Access Compliance Report

Public Rights-of-Way

(Curb Ramps)

Intersection ID: 53165	Main Street: DIXIE_RIVER_RD	Cross Street: N/A	Location: NW
ADA ID: 44946EEC2FCE	Ramp Type: Perp	Initial Pass/Fail: Fail	Overall Compliance: No
Severity Score: 25			
Codes/Mitigation Info/Possible Solution		Field Measurements/Component Compliance

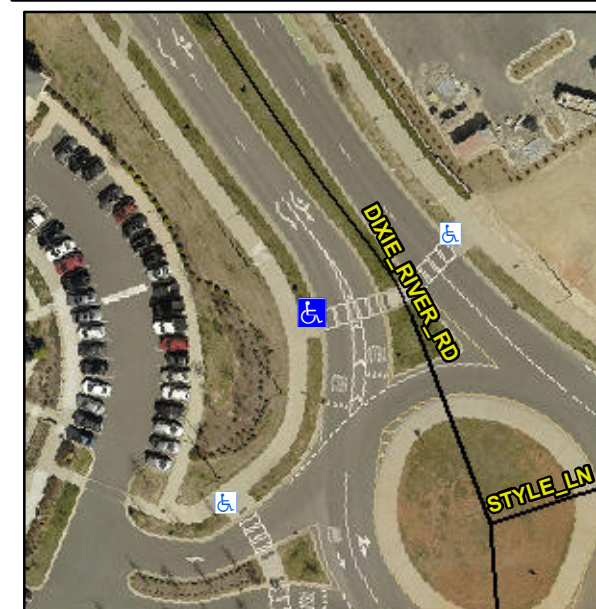
Not Found, R304.2.2, R304.5.3

Compliance	Description	Data	Compliance	Description	Data
N/A	Ramp Length (in)	95.0	No	Ramp Slope (%)	8.8
Yes	Ramp Width (in)	48.0	No	Ramp XSlope (%)	6.6
N/A	Flare Type LT	N/A	N/A	Flare Type RT	N/A
N/A	Flare Slope LT (%)	N/A	N/A	Flare Slope RT (%)	N/A
N/A	Flare Traversable LT?	N/A	N/A	Flare Traversable RT?	N/A
N/A	Landing Length (in)	N/A	N/A	DWS Provided?	N/A
N/A	Landing Width (in)	N/A	N/A	DWS Contrast?	N/A
N/A	Landing Slope (%)	N/A	N/A	DWS Length (in)	N/A
N/A	Landing X Slope (%)	N/A	N/A	DWS Full Width?	N/A
N/A	Landing Curb? (Y/N)	N/A	N/A	DWS Offset (in)	N/A
N/A	Shared Landing?	N/A			
N/A	Gutter Ponding?	N/A	N/A	Gutter Slope (%)	N/A
N/A	Gutter Lip Ht (in)	N/A	N/A	Gutter X Slope (%)	N/A
N/A	Painted X Walk1?	Yes	N/A	Painted X Walk2?	N/A
	X Walk 1 Direction	To E		X Walk 2 Direction	N/A
N/A	X Walk 1 Width (in)	113.0	N/A	X Walk 2 Width (in)	N/A
	X Walk 1 Slope (%)	1.4		X Walk 2 Slope (%)	N/A
	X Walk 1 X Slope (%)	6.2		X Walk 2 X Slope (%)	N/A

Remove & Replace Entire Ramp.
